RE: 2945 Trellis Dr. NW
Grading and Drainage Plan
Engineer's Stamp Date: 10/03/22
Engineer's Certification Date: 12/17/22
Hydrology File: G12D037B

Based upon the information provided in your submittal received 12/20/2022, the Grading and Drainage Plan is approved for Building Permit and Building Pad Certification for 2945 Trellis Dr. NW. Please attach a copy of this approved plan in the construction sets for Building Permit processing along with a copy of this letter.

<p>ENGINEER'S SEAL</p>	<p>LOTS A-4-B LANDS OF MICHAEL J. SNOW & ELIZABETH T. SNOW</p>	<p>DRAWN BY DEM</p>
	<p>GRADING AND DRAINAGE PLAN</p>	<p>DATE 10-2-22</p>
<p>10/3/22</p>		<p>SHEET # C1</p>
<p>DAVID SOULE P.E. #14522</p>	<p>PO BOX 83924 ALBUQUERQUE, NM 87189 (505) 321-9089</p>	<p>JOB # _____</p>

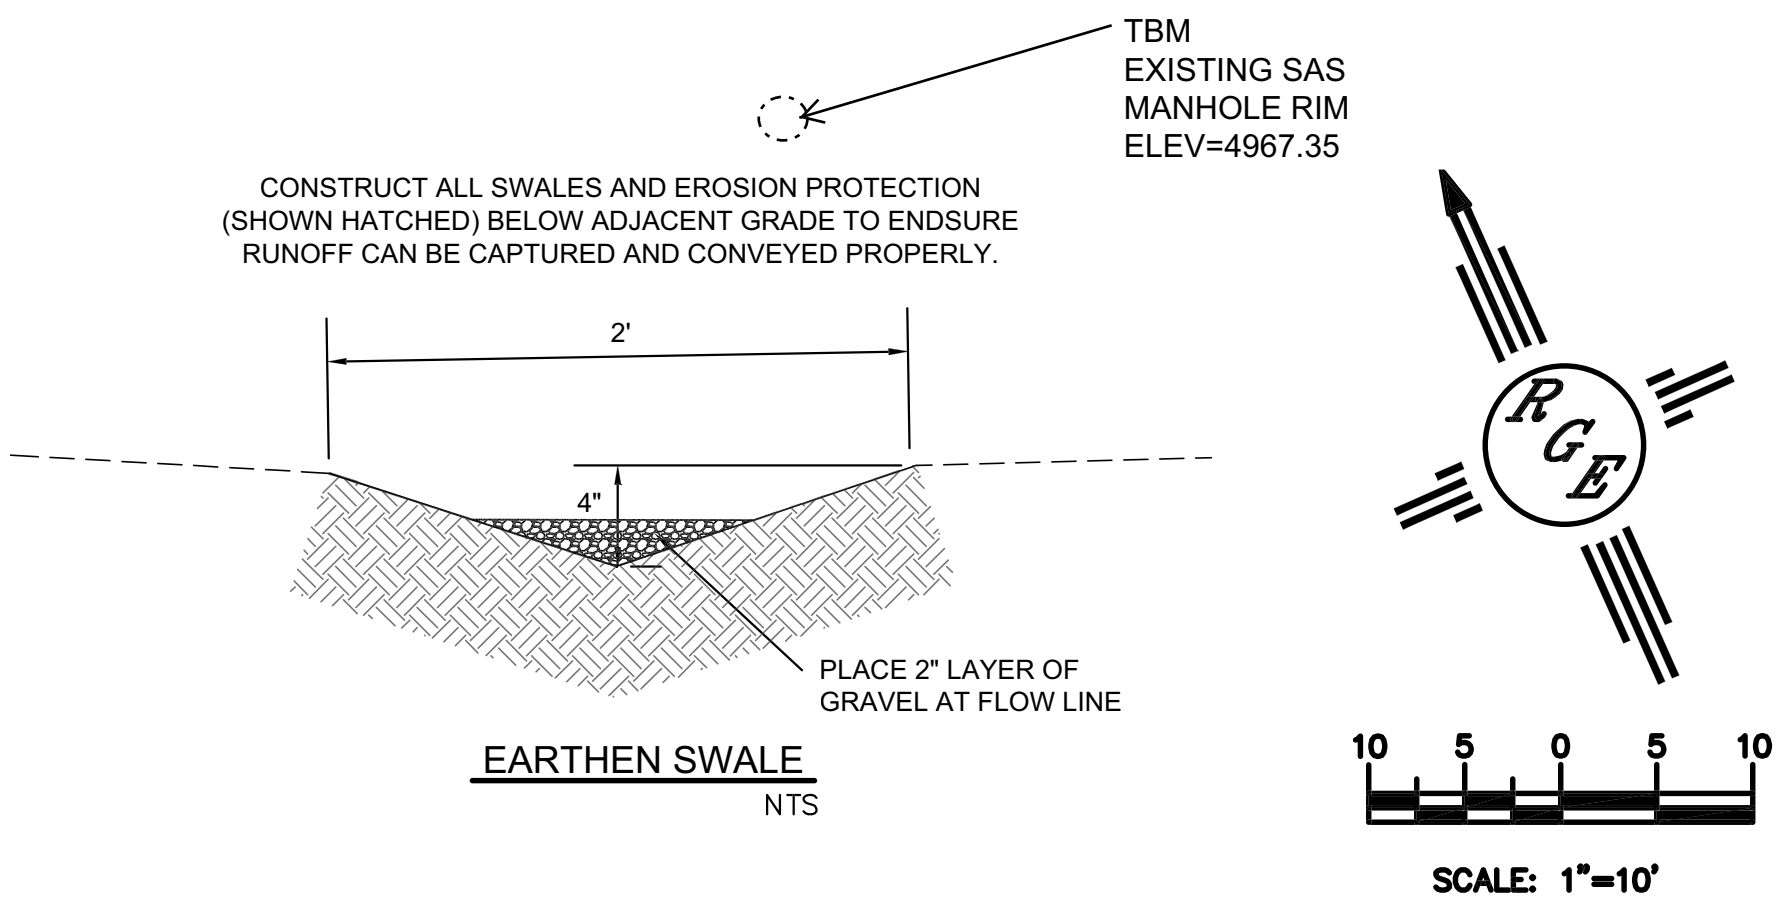
1. Engineer's Certification, per the DPM Part 6-14 (G): Engineer's Certification Checklist for Subdivision and Part 6-14 (H): Required Certification Language is required.
